RECORD OF DECISION

Ramapo Paint Sludge Site
Operable Unit Number 02: Torne Valley Road Area
State Superfund Project
Ramapo, Rockland County
Site No. 344064
March 2014

Prepared by
Division of Environmental Remediation
New York State Department of Environmental Conservation

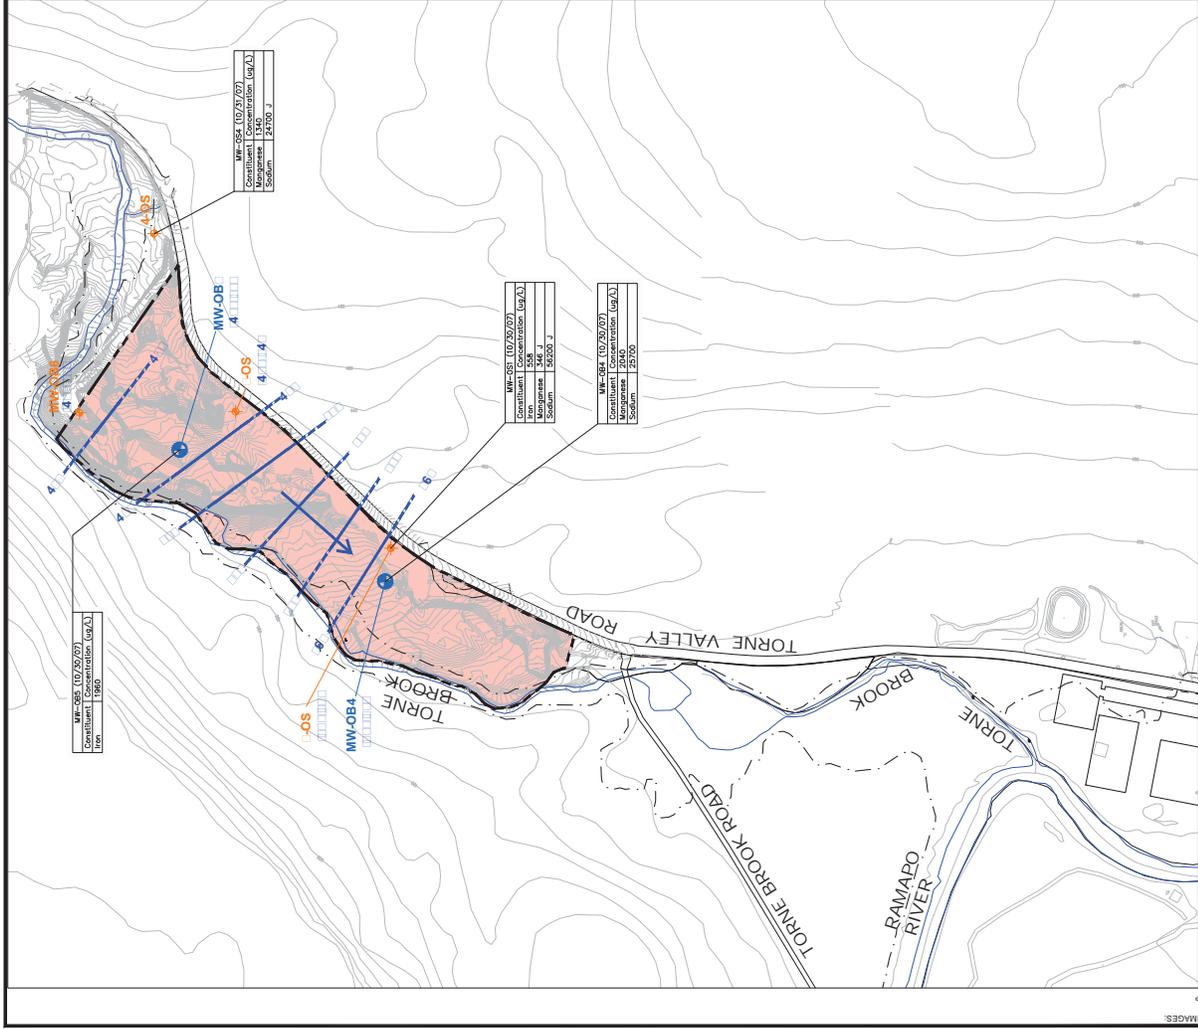
COMMENT 11: Reference to the Torne Valley Recreational Center is incorrect. The facility is now called the Joseph T. St. Lawrence Center.

RESPONSE 11: Figure 2 has been corrected to indicate the correct name.
